UNITED STATES  
DEPARTMENT OF THE INTERIOR  
BUREAU OF LAND MANAGEMENT  
**APPLICATION FOR PERMIT TO DRILL OR REENTER**

| Property Code<br><b>329970</b>    | Property Name<br><b>DEEP ELEM 4 FED COM</b> | Well Number<br><b>804H</b>                |

## PECOS DISTRICT DRILLING CONDITIONS OF APPROVAL

Proposed Wellbore  
Design A

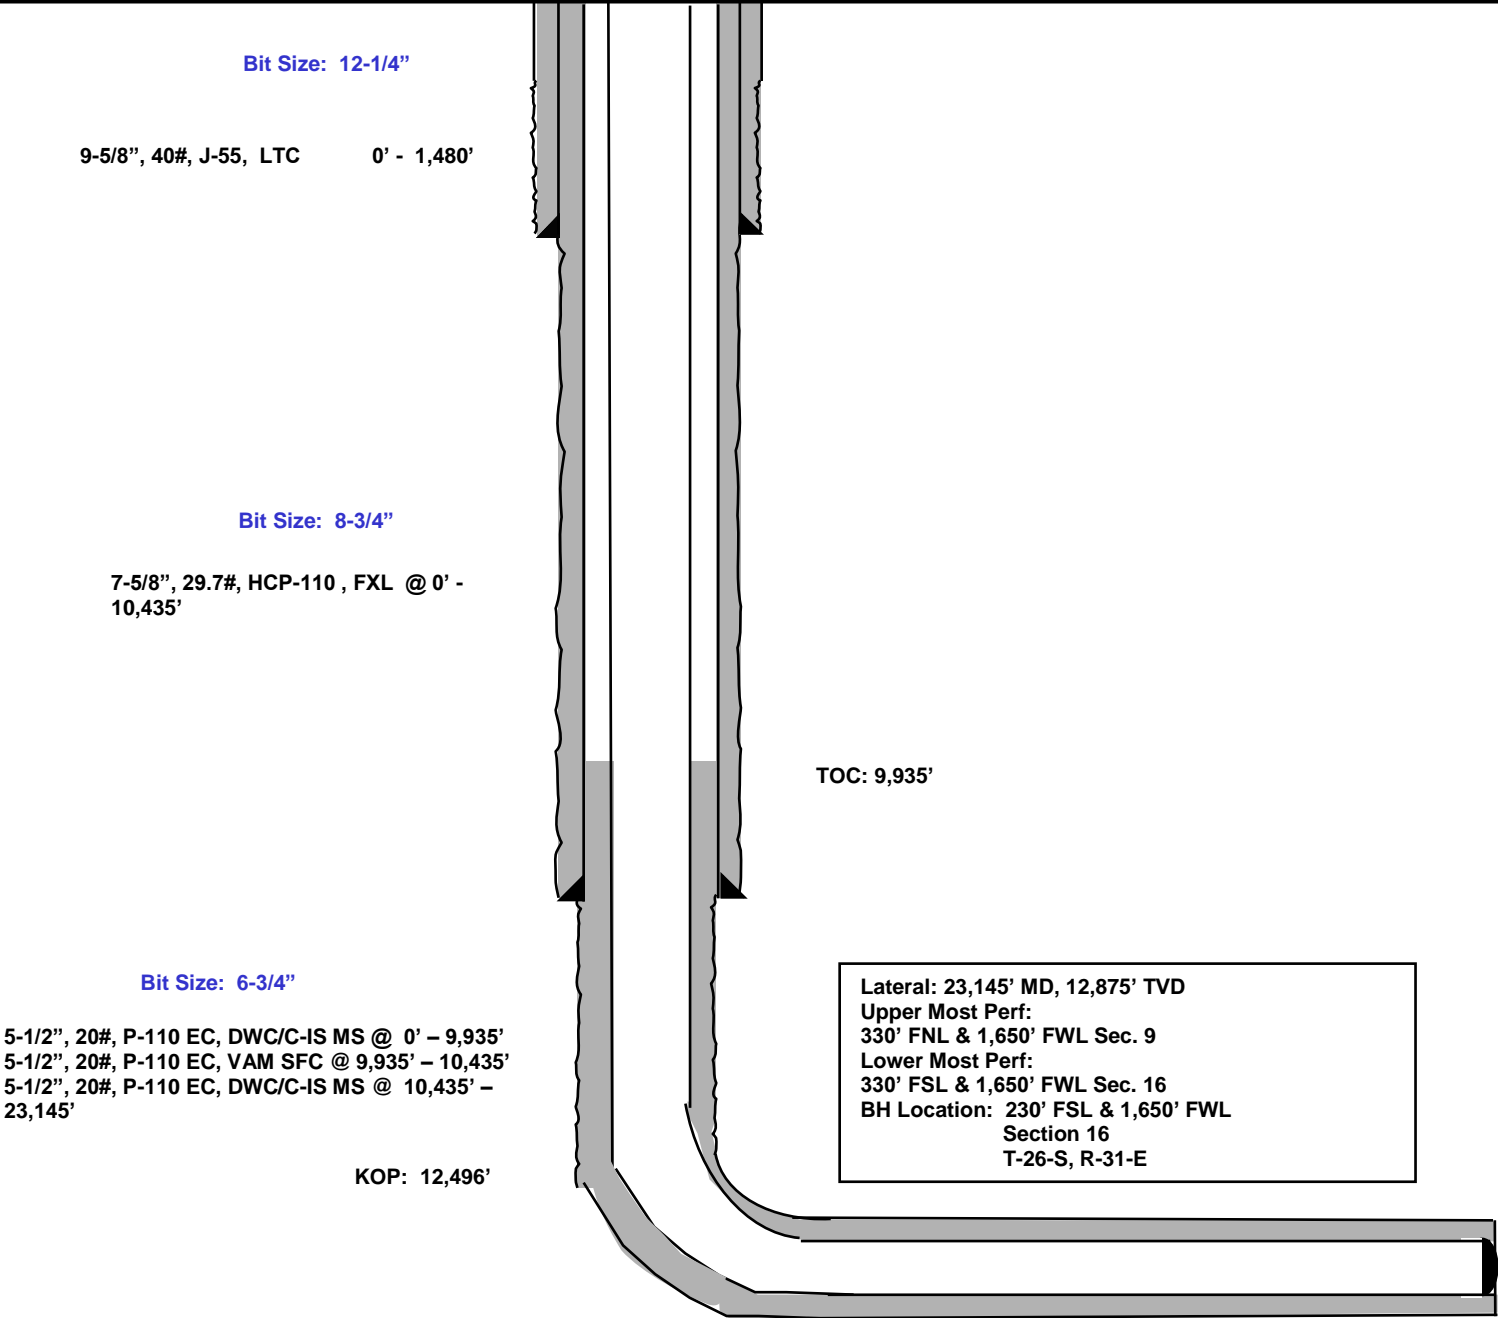
EOG requests to pump a two stage cement job on the 7-5/8" intermediate casing string with the first stage being pumped conventionally with the calculated top of cement at the Brushy Canyon (6,330') and the second stage performed as a bradenhead squeeze with planned cement from the Brushy Canyon to surface. If necessary, a top out consisting of 1,000 sacks of Class C cement + 3% Salt + 1% PreMag-M + 6% Bentonite Gel (2.30 yld, 12.91 ppg) will be executed as a contingency. Once cement circulates to surface drilling operations to drill out of the intermediate shoe will proceed (per clarification from BLM 4/21/2020). The final cement top will be verified by Echo-meter.

**Operator has proposed to pump down 9-5/8" X 7-5/8" annulus after primary cementing stage. Operator must run Echo-meter to verify Cement Slurry/Fluid top in the annulus Or operator shall run a CBL from TD of the 7-5/8" casing to surface after the second stage BH to verify TOC.**

| Created By  | Condition  | Condition Date |
|-------------|--|----------------|
| ward.rikala | If a bradenhead squeeze is used for the intermediate casing, then NM OCD will require a CBL to verify the integrity of the cement behind the intermediate casing.  | 8/17/2023      |

**Proposed Wellbore**  
**Design B**

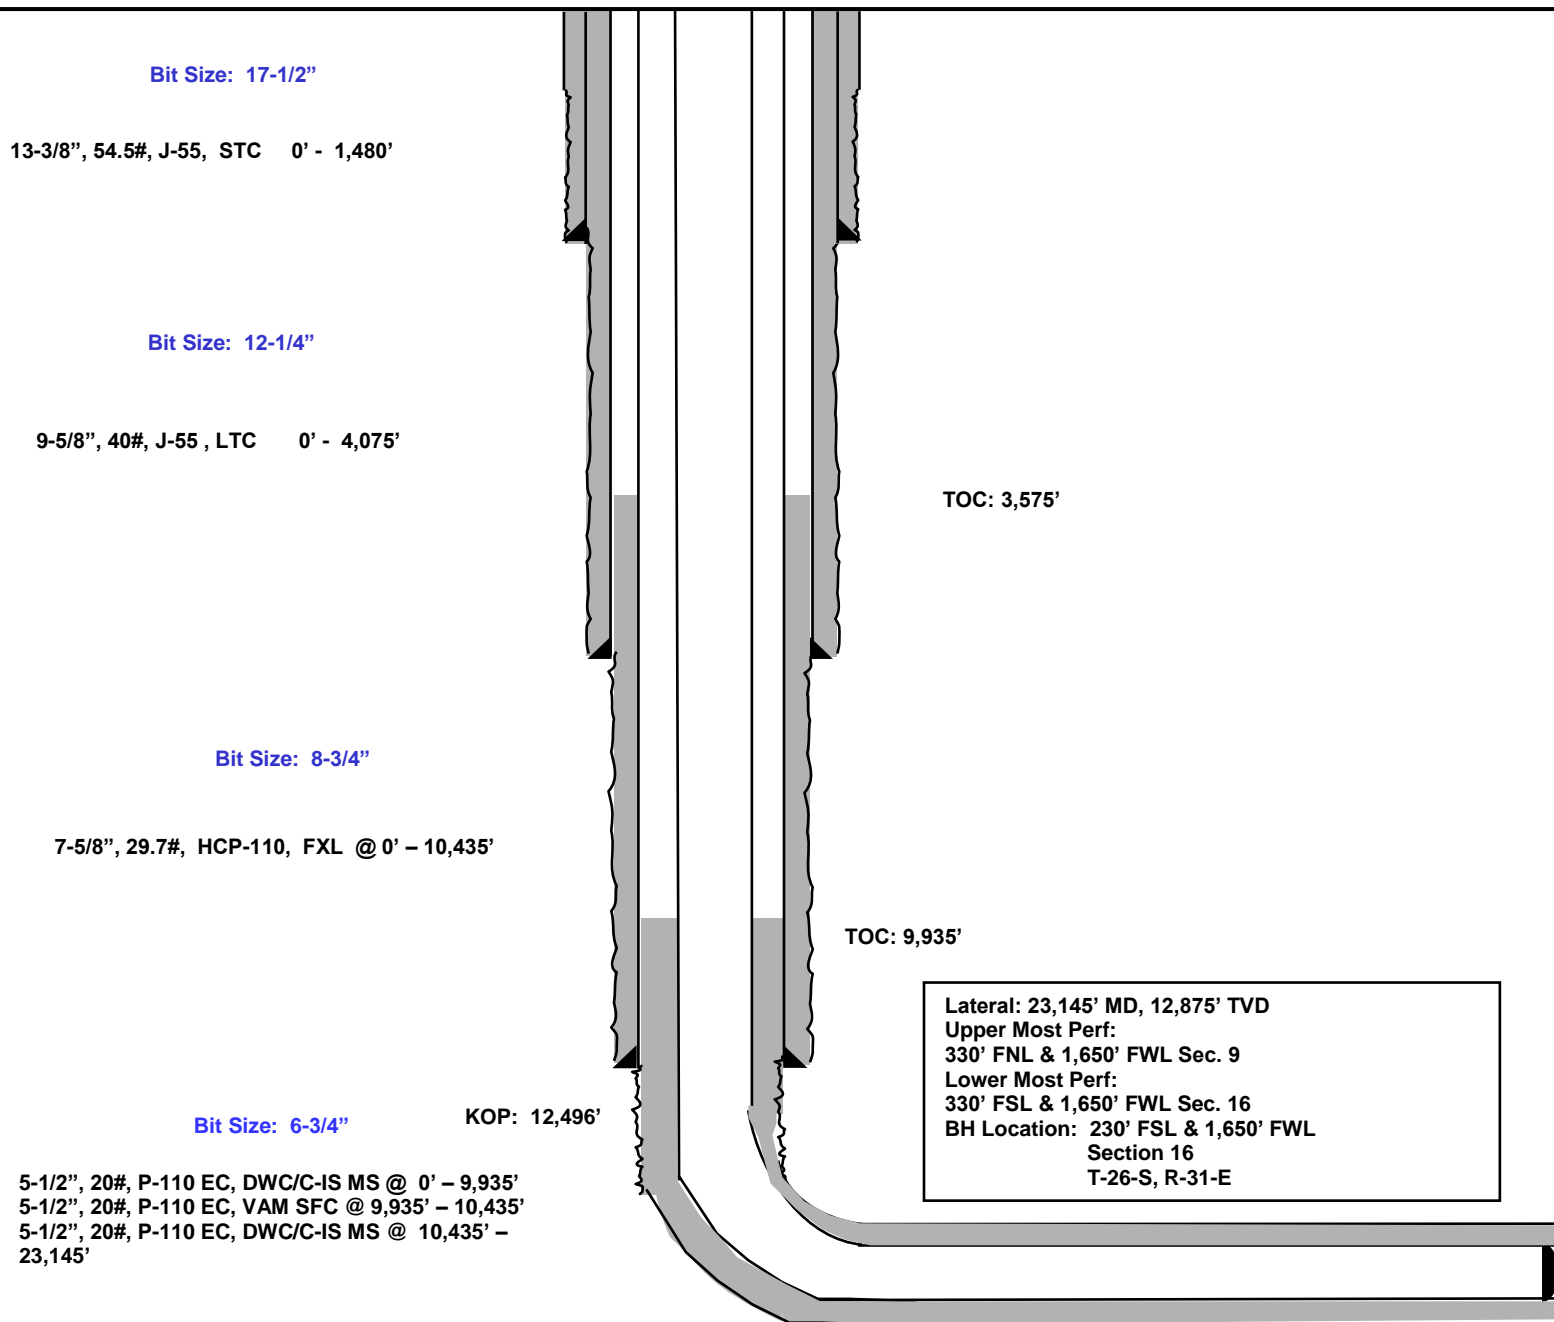
EOG Resources also requests approval to implement Casing Design B (pg. 8-9). BLM will be notified of elected design at spud.

**Operator is only approved for Design A. Design B is not to be utilized. If Design B is needed or any other change, please submit a NOI sundry to make the changes.**
